Rock Creek Forest Elementary School, Mandatory Referral, 2013014

Review of the Rock Creek Forest Elementary School modernization plan

Staff Recommendation: Approval to transmit comments to Montgomery County Public Schools.

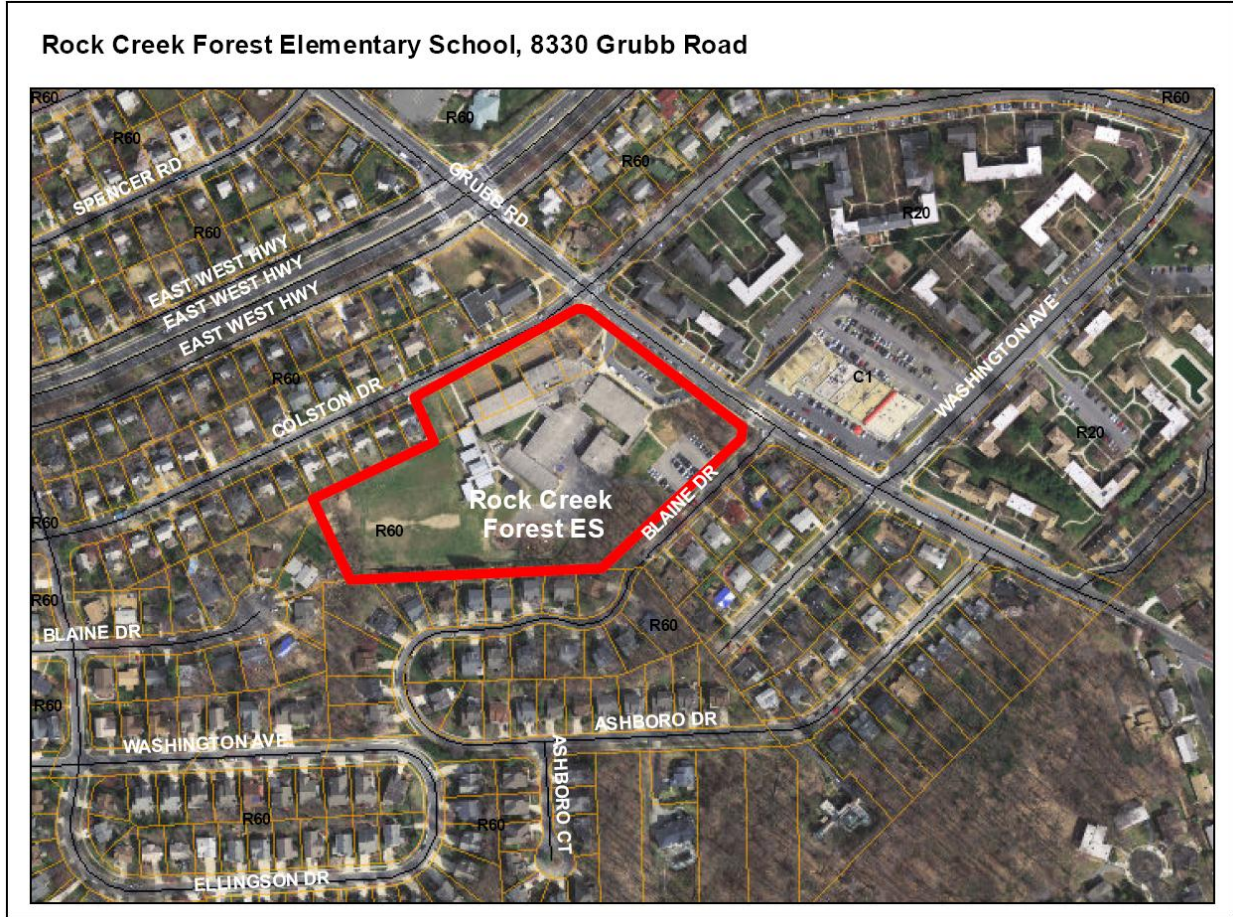
- Any mandatory referral submission for future improvements at the school must include a traffic study if those improvements will increase the school's student core capacity beyond 740 students.
- Move the sidewalk at the southwest corner to the back of the ramp at the Grubb Road proposed driveway, to keep the sidewalk at the same grade around the curve.
- Increase the width of the median refuge area for the Grubb road driveway to at least 6 feet.
- Move the sidewalk at the west corner to the back of the ramp at the Colston Drive proposed driveway, to keep the sidewalk at the same grade around the curve.
